# 1997 Corvette: Service Bulletin: Water Drips into Rear Compartment After Hatch/Glass Has Been Opened

**Number:** 73-10-55

**Models:** 1997 Chevrolet Corvette

Figure 1 - Sideview

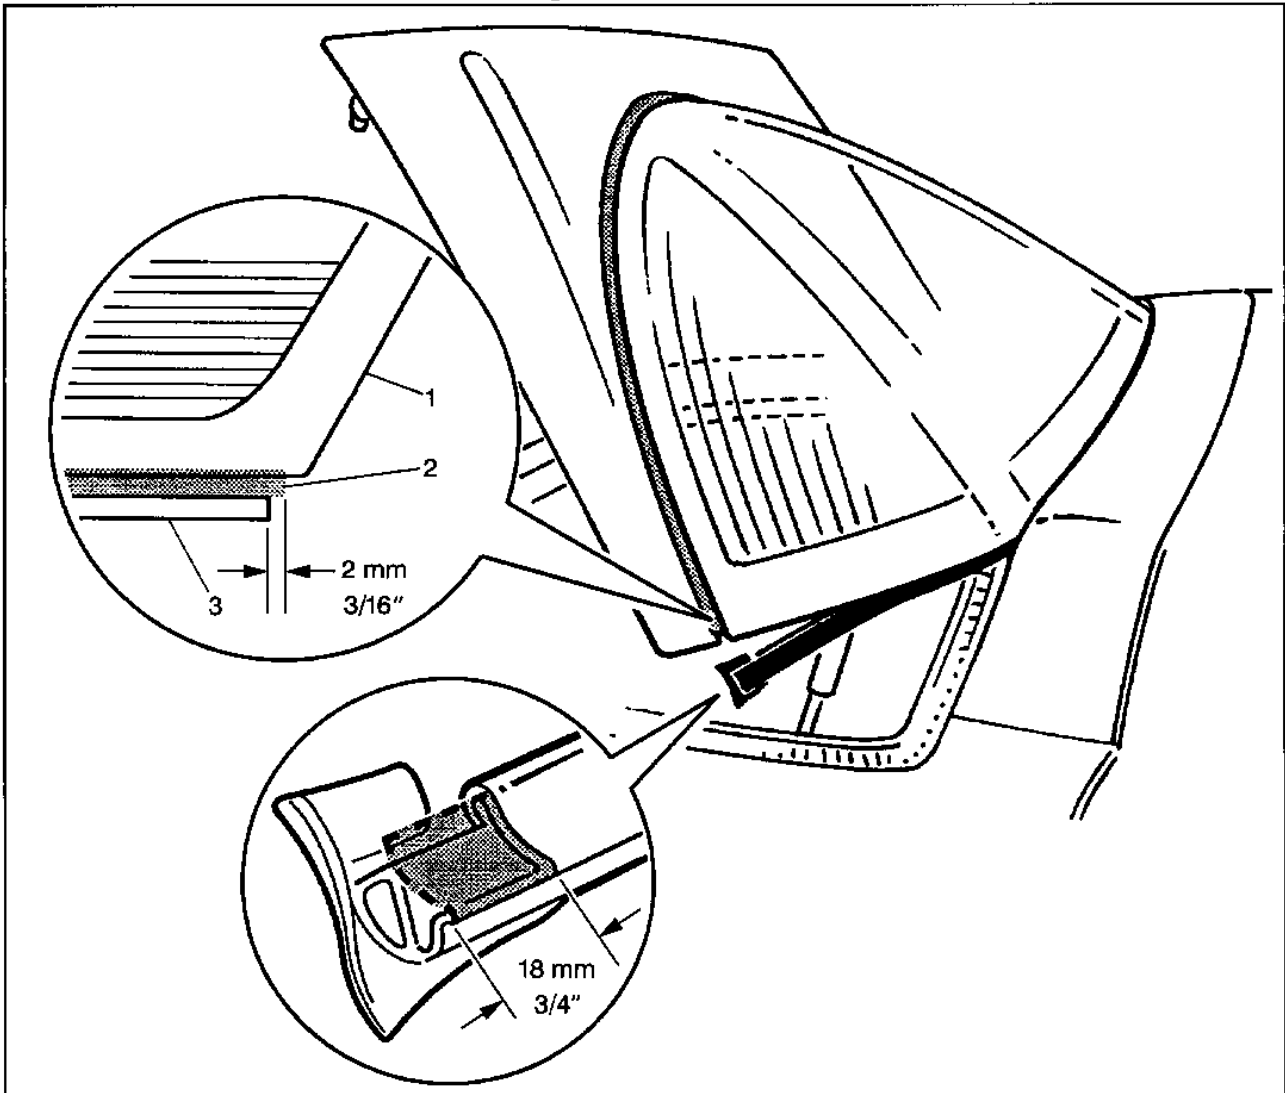
**Condition:** Some owners may comment that water drips into the rear compartment after the hatch glass has been opened.

**Correction:** Modify weatherstrip following instructions below.

1. Pull down weatherstrip to gain access to the end of the black close out weatherstrip (see Figure 1, top view). With a utility knife, cut the close out weatherstrip so there is a 2 MM (3/16 in.) overhang of the weatherstrip to its mounting surface (See Figure 1, top view)
2. With weatherstrip pulled down, measure 18 MM (3/4 in.) from end of weatherstrip and remove shaded area from weatherstrip (see Figure 1, bottom view). Reinstall weatherstrip on hatch.
